# **SUPPLEMENTARY TEST AND EVALUATION REPORT**

## **ADVANCED 918 LIGHT TABLE**

**NPIC-56/70  
OCTOBER 1970**

T & E Report No. 69-04  
Supplement

FIGURE 2. Rear View - All Handwheels with Handles Removed

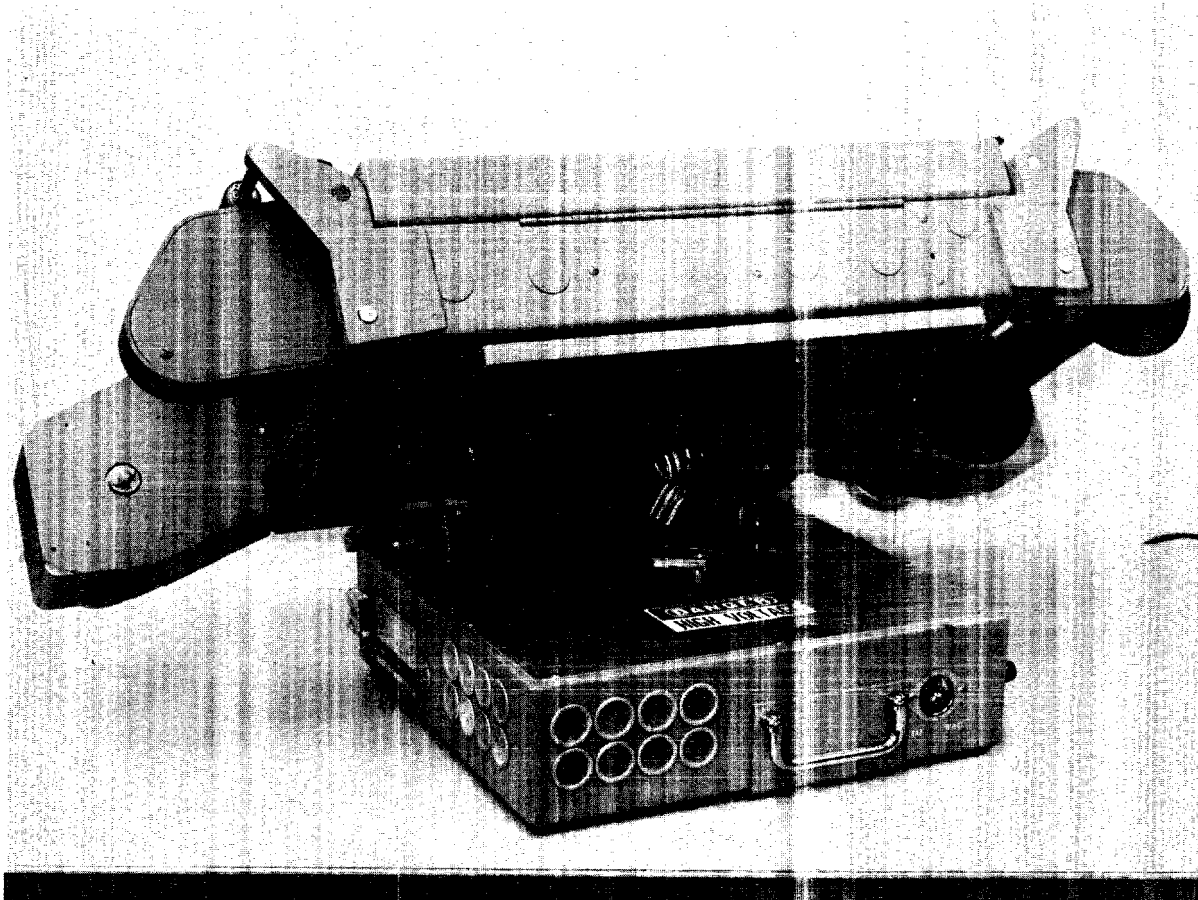
Revised Specification - "The bidirectional manual drive system, consisting of handwheels, chain drives, electric clutches, slip clutch, direction switching microswitches, etc., must be removed as well as the manual tension controls. Openings left in the shell must be covered."

"Handwheels must be added to the outboard ends of the motor shafts. These handwheels are to be without handles and should be designed as shown on the accompanying drawing." (Drawing supplied was for a knurled edge,  $3\frac{1}{2}$  to 4 inch handwheel.)

Changes Made By Contractor - The manual film drive mechanism of the original design has been removed. It consisted of three handcranks all connected by chain through a series of sprockets, idlers and shafts. Before removal this produced excessive tension, and manual transport was rough and extremely difficult. The Light Table now has three and three-quarter inch diameter knurled edge handwheels on the outboard ends of the motor shafts. See Figures 1-3. These wheels turn during power transport. Since the motor drive will move film fast or slow across the viewing stage the handwheels are needed only for transporting film short distances or for rewinding film in case of electric power failure.

FIGURE 4. Disassembled Motor.  
White Silicone Rubber Placed on Brush Springs to Eliminate Noise

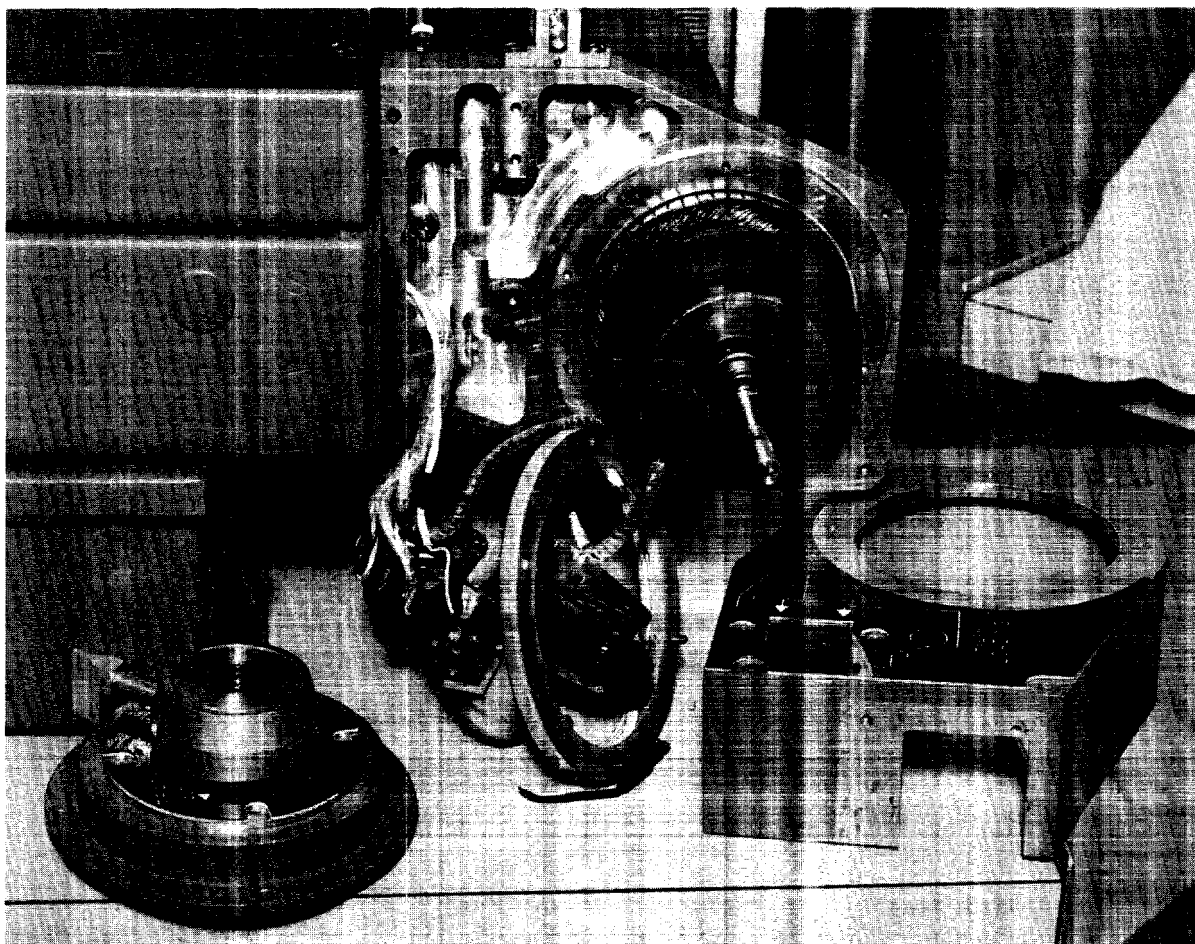
To Be Modified Or Repaired - "The cause for the squeal in the left motor and the cause for the knocking in the left movable bracket assembly must be eliminated."

Changes Made By Contractor - The original tests conducted on the prototype table revealed a high frequency squeal when the left motor was rotated counterclockwise. This noise, in the range of 5 to 7 KH, was very disturbing to operators and nearby personnel. When the reworked model was delivered this condition had not been eliminated so the contractor was notified that the table was not acceptable. In September 1969 a representative from [ ] visited NPIC to correct this situation. It was found that the squeal was due to a high frequency vibration in the motor brush springs. By coating these springs with a silicone rubber material the noise was eliminated. Two of the coated flat springs appear inside the narrow plastic ring in the center of Figure 4.
